WCAP-15872-NP-A, Rev. 0

Subject: Westinghouse Owners Group
Transmittal of NRC-Approved Topical Report WCAP-15872-NP-A, Rev 0, (Non-Proprietary) "Use of Alternate Decay Heat Removal in Mode 6 Refueling," (TAC MB9020) (Task 2075)

Use of Alternate Decay Heat Removal in Mode 6 Refueling

**RESPONSE TO NRC
REQUEST FOR ADDITIONAL INFORMATION
DATED OCTOBER 2, 2003**

Figure A-3
Sample Cases: Average Refueling Pool Temperature

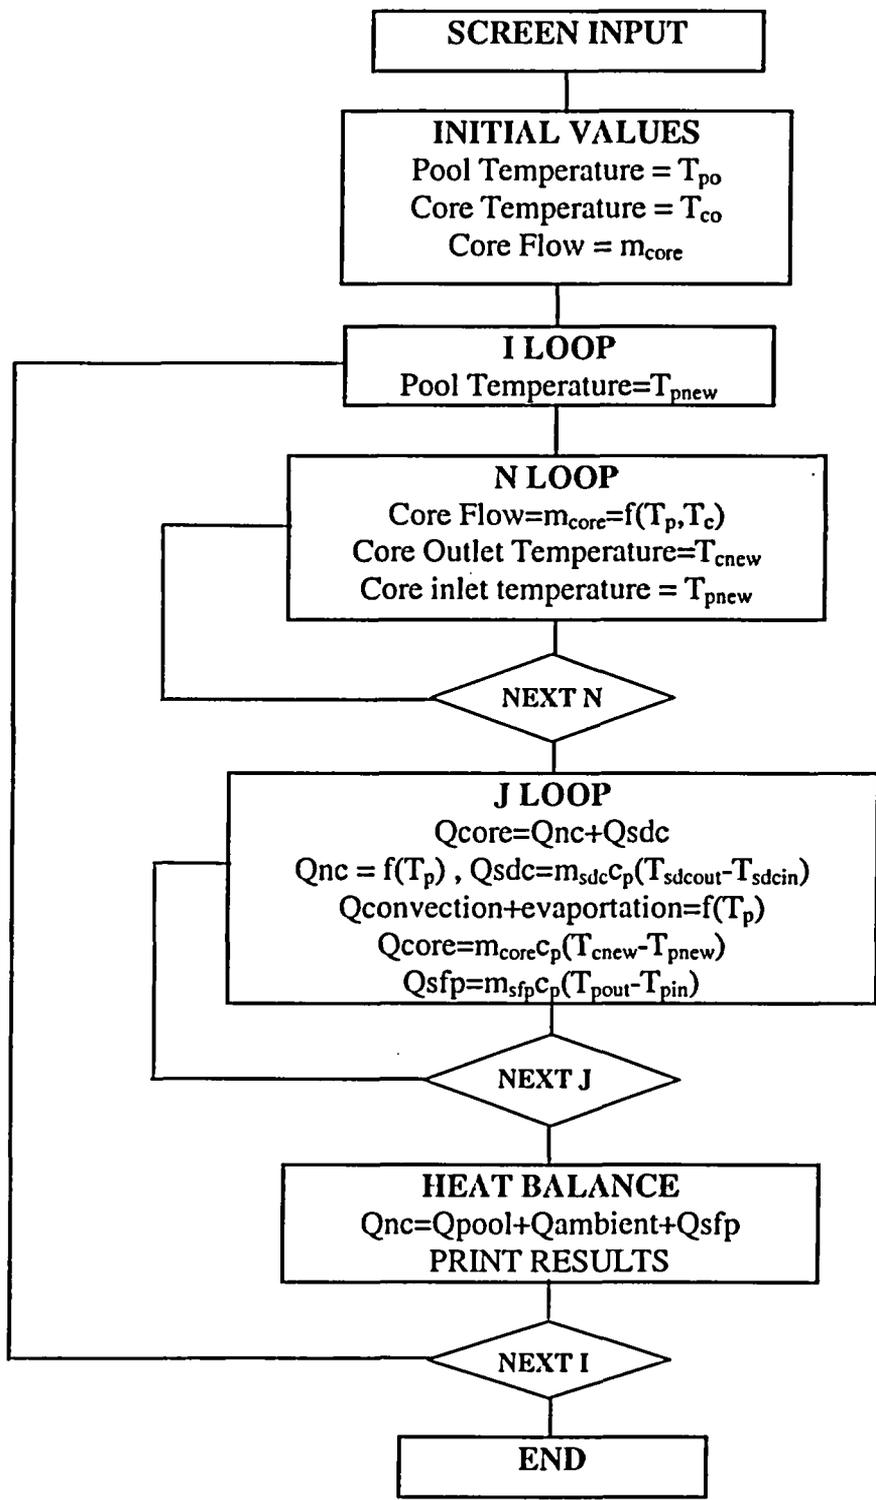
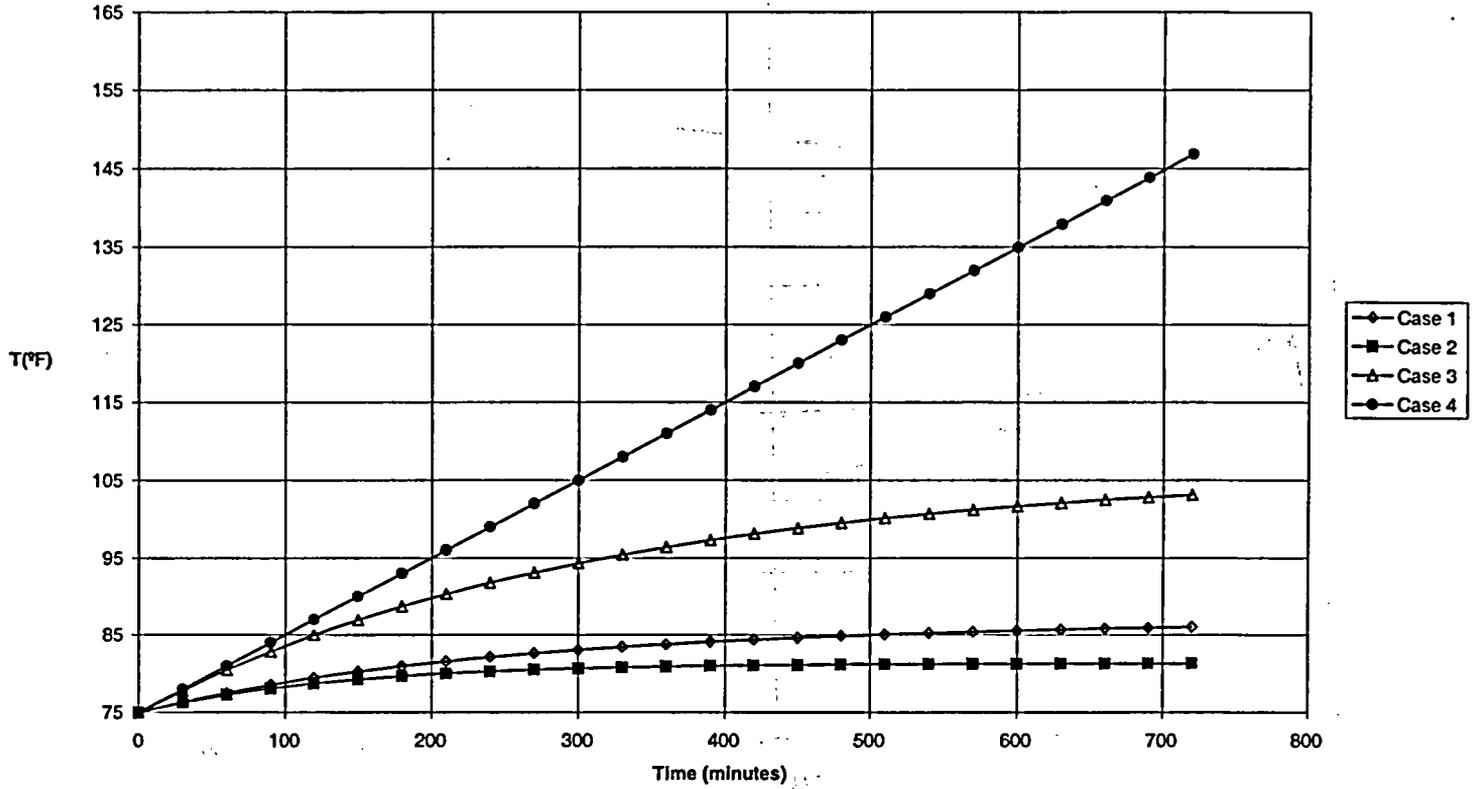
RAI A7. Please show the derivation of the values of ϵ_{mix} and ϵ_{bypass} used in the results shown in Figs. A-3 and A-4 for Case 2 and Case 3.

The mixing and bypass coefficients are defined in Appendix A and derived as shown in Appendix D. However, for the results shown in Figure A-3 and Figure A-4, these coefficients were assumed well mixed, i.e., $\epsilon_{mix} = 1.0$ and all alternate heat removal flow fully mixed with the natural convection flow from the core, $\epsilon_{bypass} = 0.0$. In Appendix A, Case 2 represents full SDC flow plus alternate cooling flow; Case 3 represents only alternate cooling flow. (Note that sample Cases 1 – 4 in Appendix A are not the same as test Cases 1 – 4 listed in Appendices B, C and D.)

Figure B-1
CCNPP Unit 2 Outage Tests: Flow Alignments

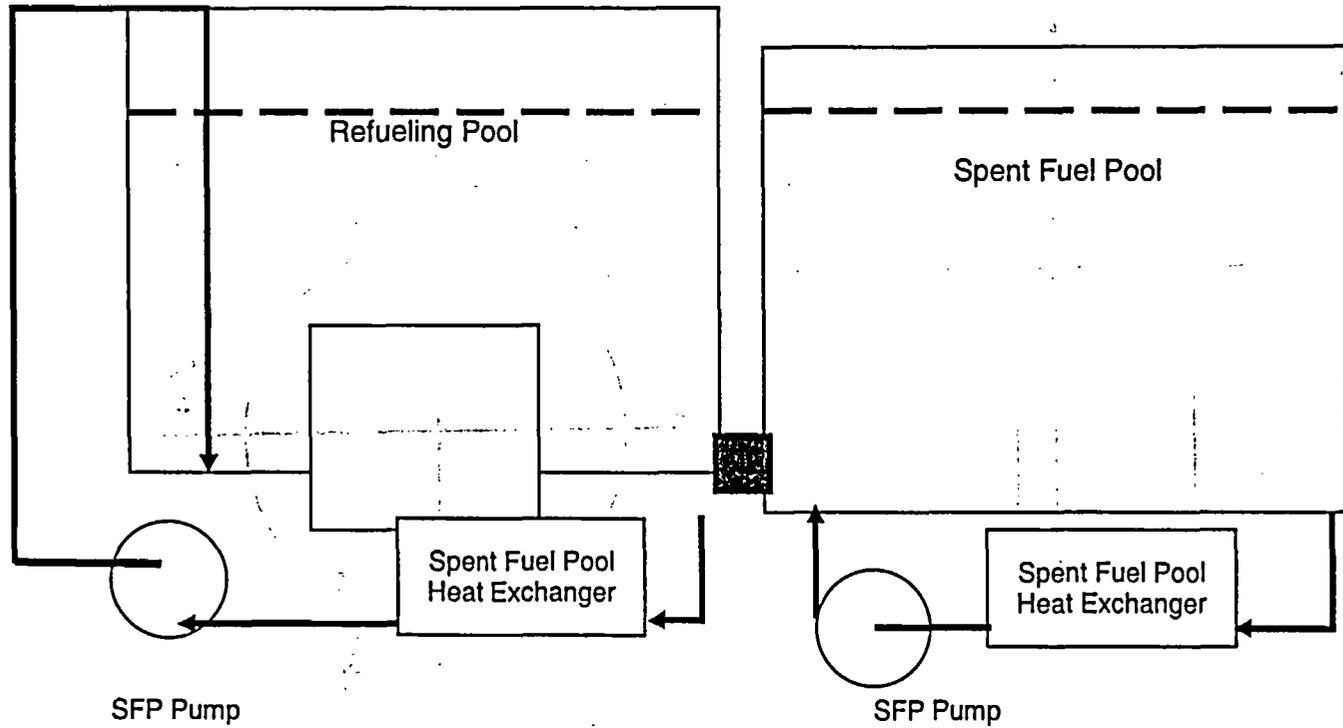
RAI B1. Fig. B-1 is confusing. Under the alternate cooling alignment do you have a separate spent fuel pool (SFP) pump and heat exchanger for both the refueling pool and the SFP, or do these represent separate alignments? Please indicate the complete flow paths of fluid associated both with the refueling pool and core, and the SFP. In your figure, how and when do you get flow "from the refueling pool to the spent fuel pool?"

Figure B-1 illustrates the specific alternate heat removal alignment at CCNPP. The figure describes the capability to align a "spare" spent fuel pool cooling train to cool the refueling pool while a second train remains aligned to the site's spent fuel pool.

The actual configuration of the alternate cooling alignment implemented at other plants may vary depending upon the available plant equipment capabilities. Refer also to Figure 1 of WCAP-15872 which illustrates a generic shutdown cooling decay heat removal system, and to Figure 2 which illustrates the decay heat removal flow path when using the Alternate Heat Removal process. A different alternate heat removal alignment may be selected by other plants, depending on the heat removal loops available to cool the refueling pool. The alternate heat removal process does not envision altering the traditional method of cooling the spent fuel pool.

Figure D-2
Flow Paths for Bypass Flow

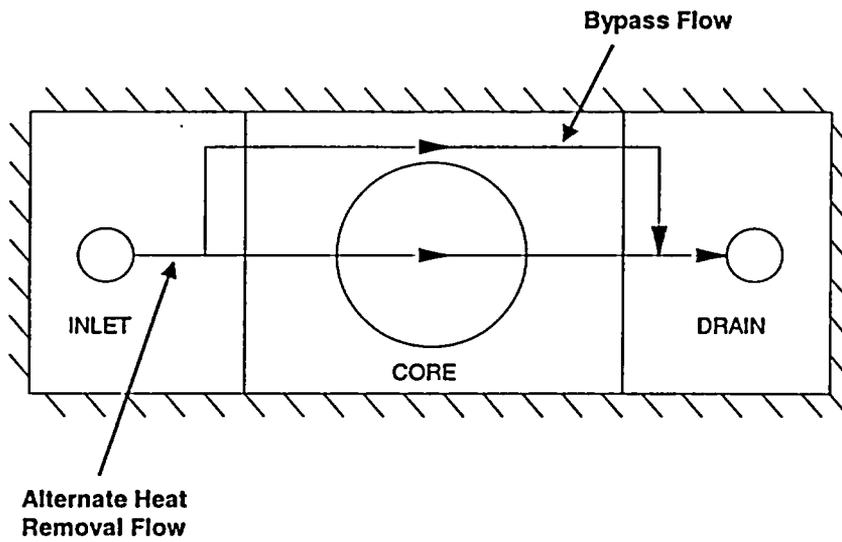
RAI D1. Please describe the simplified one-dimensional computational model and its relation to the two-dimensional computational fluid dynamics model. How does it differ from the one-dimensional model discussed in Appendix A? When you say "computational fluid dynamics model" (without the adjective "one-dimensional") in D.3, what are you referring to - A 3D model? Figures D-3 through D-6 give 2D results. So, how are you treating the situation in Figure D-2?

The mixing and bypass coefficients reflect three-dimensional effects into the one-dimensional analysis, shown in Appendix A, for natural circulation flow rates and refueling pool temperatures. The mixing coefficient is a measure of the uniformity of the refueling pool temperature, while the bypass coefficient, represented schematically in Figure D-2, is an indicator of the flow rate from the alternate cooling alignment that bypasses the natural circulation plume from the core.

Figure E-3

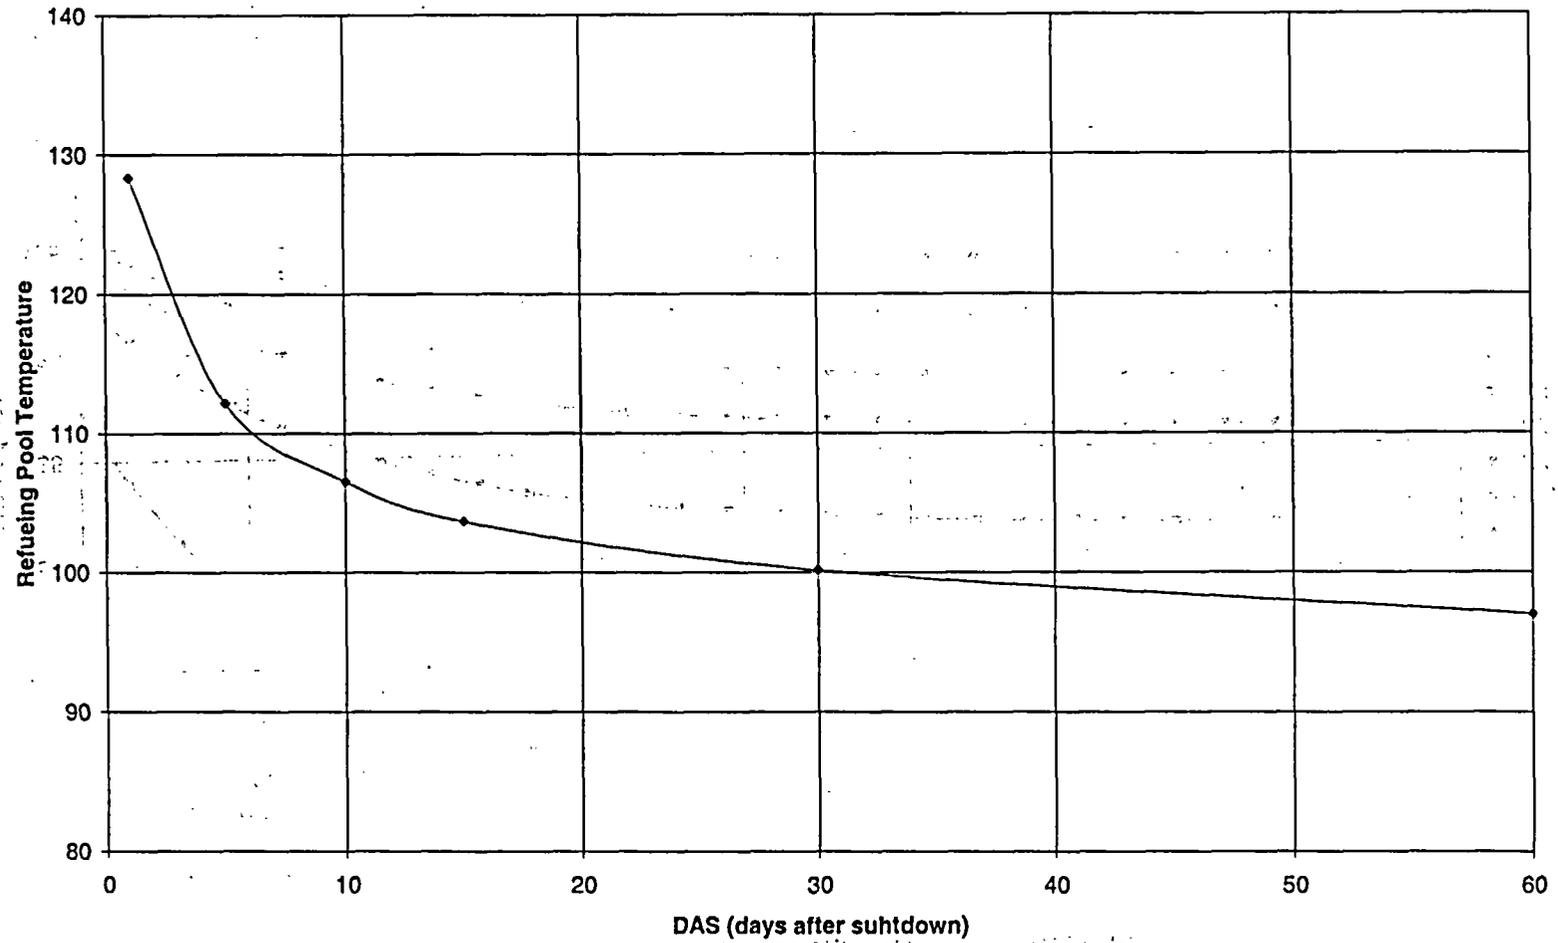
RAI E1. In section E.1, your discussion of Figure E-3 is inconsistent with the text. The text indicates that the initial refueling pool temperature is 75°F, while the value in the figure at t = 0 is 90°F.

The initial temperature of the refueling pool was taken as 90°F in the analysis. Page E3 of Appendix E has been corrected to be consistent with Figure E-3.

Figure E-5

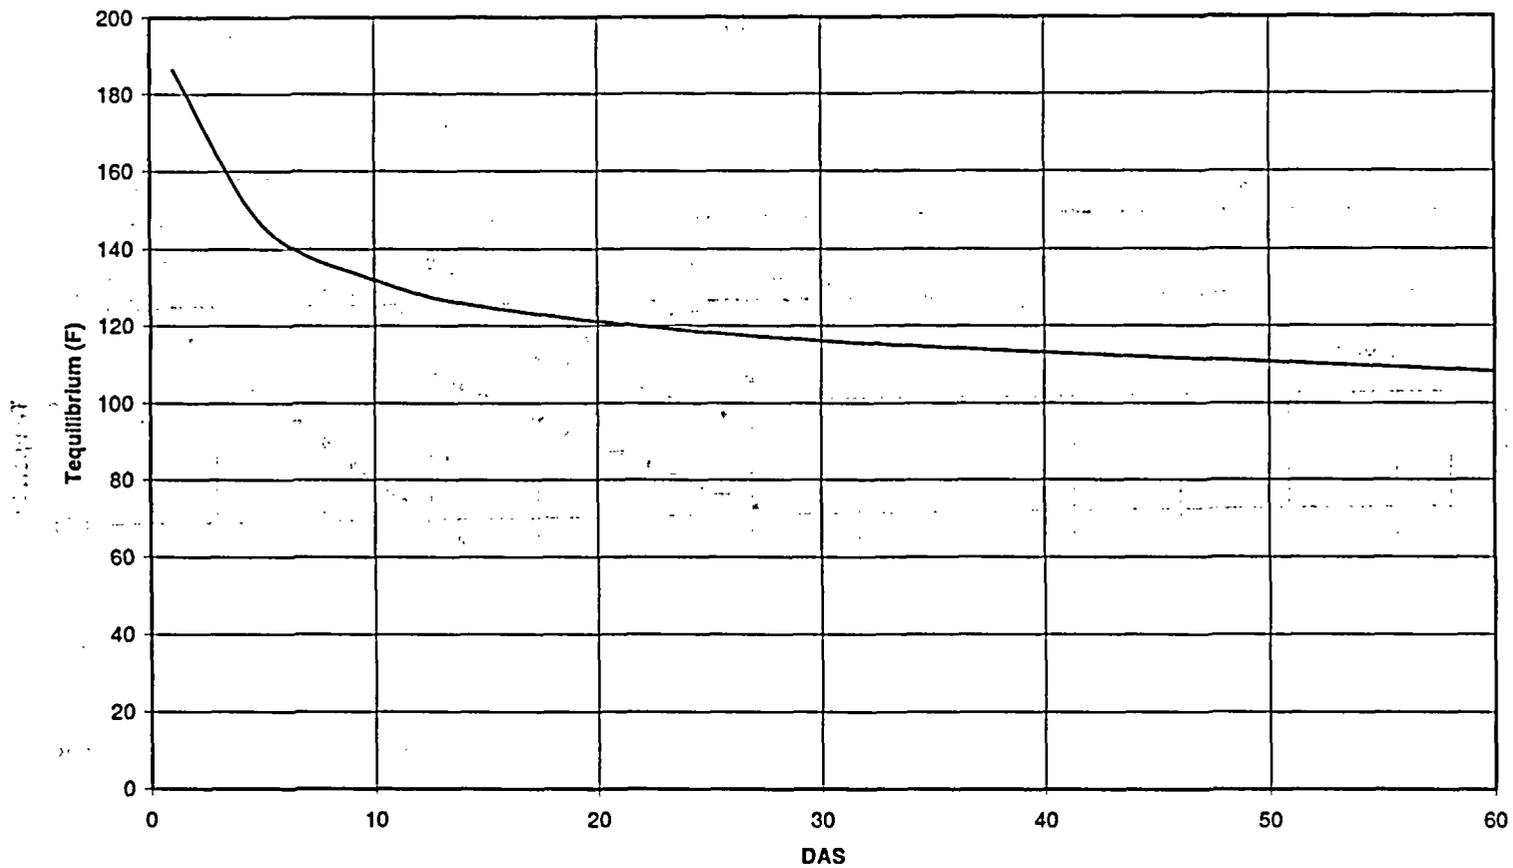
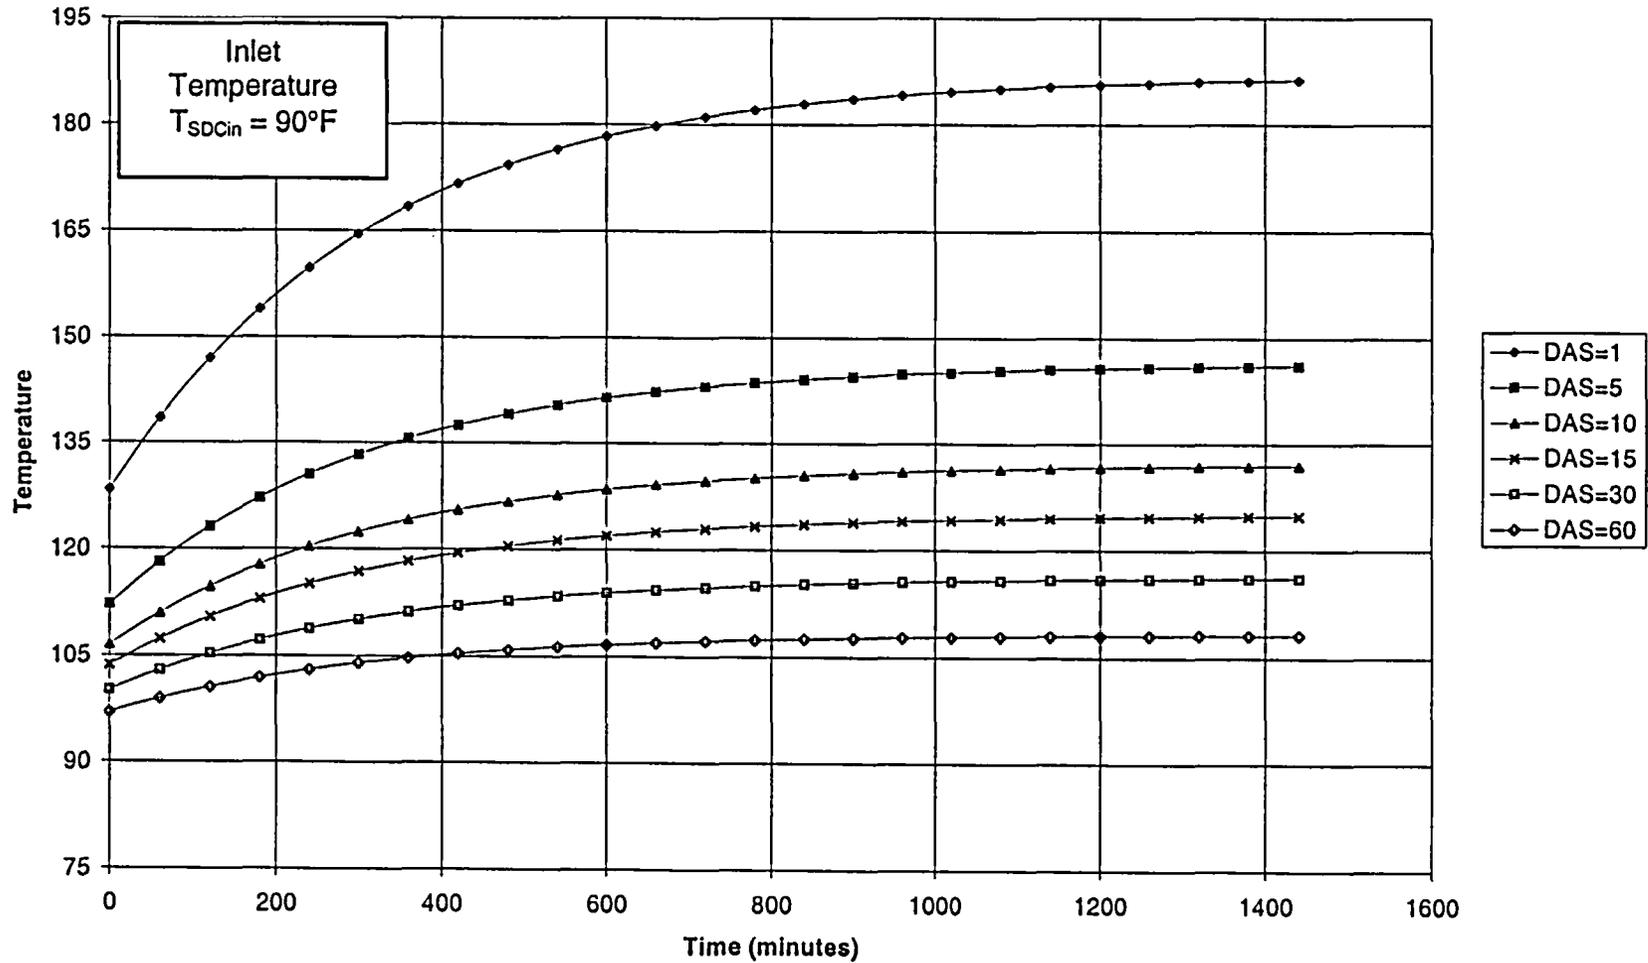
RAI E4. In the paragraph Limiting THS vs. TAS on page E4, Figure E-5 does not show a family of curves. What do you mean by a 90°F heat sink temperature when the refueling pool inlet temperature is also 90°F?

The statement has been corrected to refer to Figure E-4, not E-5. Figure E-5 is a cross-plot of the data shown on Figure E-4. The heat sink statement refers to the temperature of the heat sink for heat removal, which in this case is the inlet temperature to the spent fuel pool heat exchanger.
